Application Number	PT8GC231
Applicant Name	Galway County Council
Development Address	Eanach Dhúin/ Annaghdown Co. Galway

I Robert Mulryan live opposite the proposed graveyard. I think there are several improvements that could be made to the graveyard design such as putting the entrance on the main road with a normal car park, buying the entire field and connecting the new & old graveyards by footpath for safety.

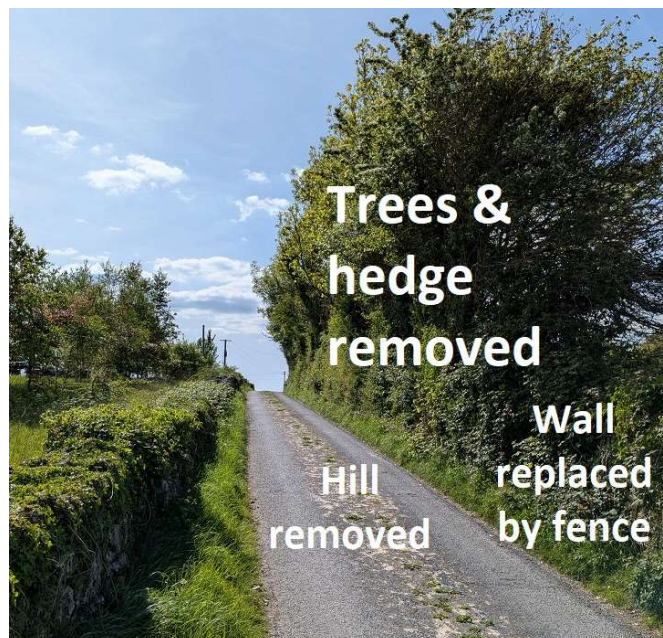
- Removal of bends in the main road

An entrance on the main road would remove several dangerous bends on the main road.

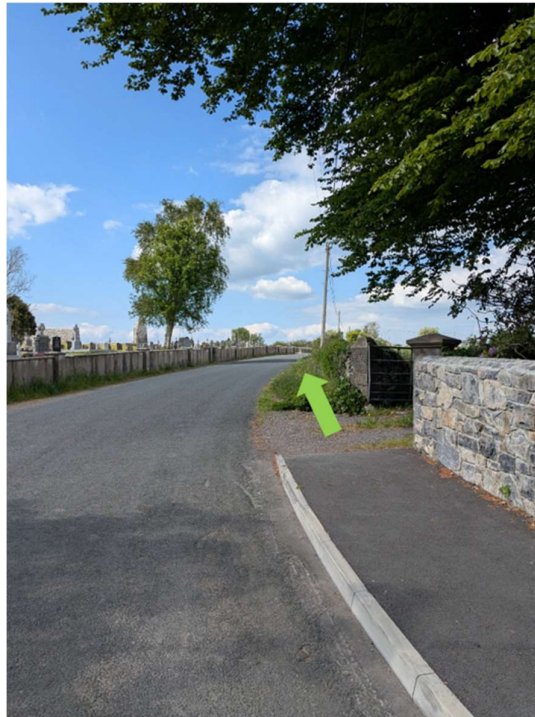
2. The council must buy the whole field

- Proposed graveyard could be full again in 30 years
The proposed graveyard has 315 plots and the parish has 10 bereavements per year. Therefore, the proposed graveyard could be full again in just over 30 years (probably much sooner as the graveyard is not restricted to people with a link to the area). It took around 10 years to find this field, will it be possible to find another field in 30 years?

- To have a graveyard for the next 100 years
The council must buy the entire field to provide a graveyard for the next 100 years. Per the councils burial ground policy, the council pays agricultural prices for land (approx. €10,000/acre). There is about 3 acres remaining in the field. The €30,000 needed to buy the rest of the field could be easily funded by the presale of around 40 double plots. (€726 each). This opportunity to buy the whole field must be taken to future proof the graveyard needs of the area.

- Normal car park
A normal car park will be possible with enough spaces to get all cars attending burials in off surrounding roads.
- Space for all graves to face east to the rising sun like the current graveyard instead of the proposed half facing east & half facing west.

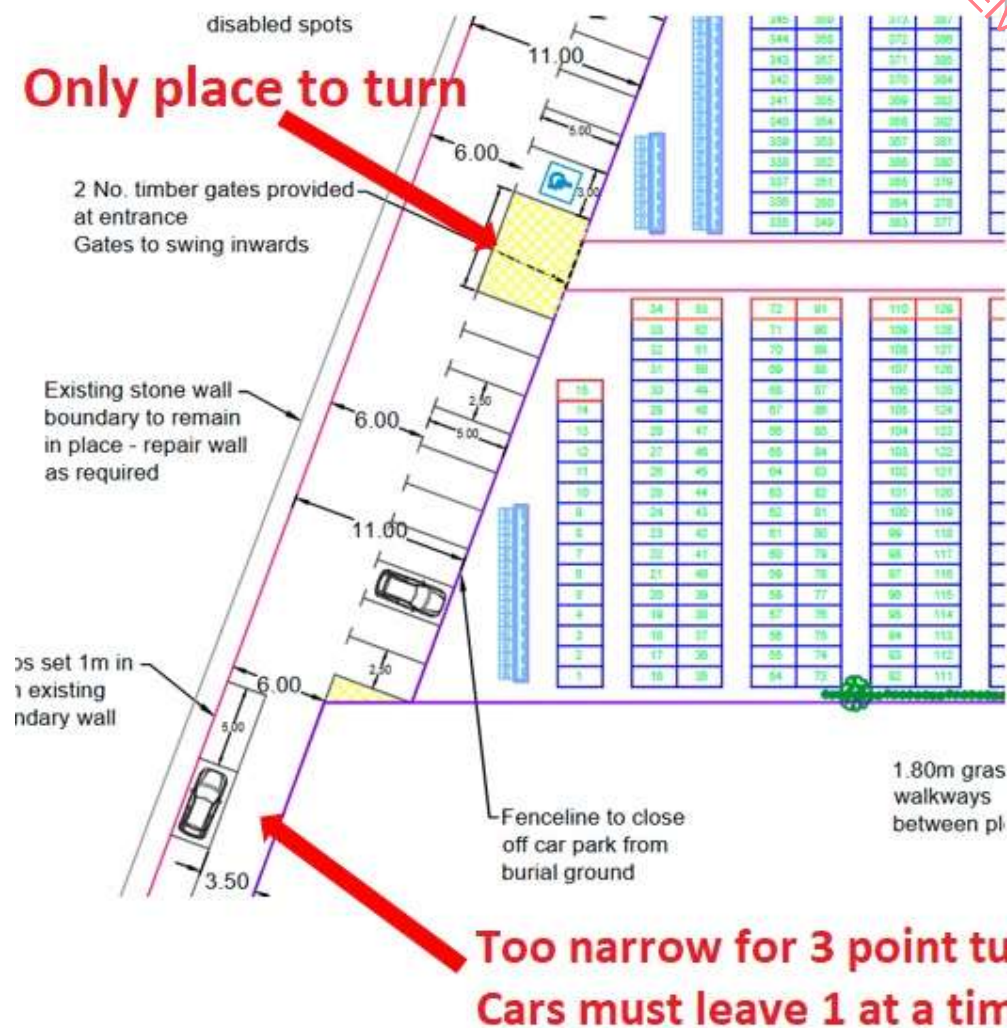
4. How do cars parked on the access road leave after burials?

- After burials, the cars parked on the access road will leave before the family cars parked at the graveyard.
- The access road is too narrow to do a 3-point turn.
- Cars parked on the access road must drive up to the graveyard gate to turn.
- 1 car leaving blocks the access road so cars must leave 1 at a time slowing everything down.
- People looking for a discreet and efficient get away after a burial will naturally park on surrounding roads & outside houses which creates unnecessary health & safety risks.
- A normal car park on the main road cuts out all these unnecessary problems.
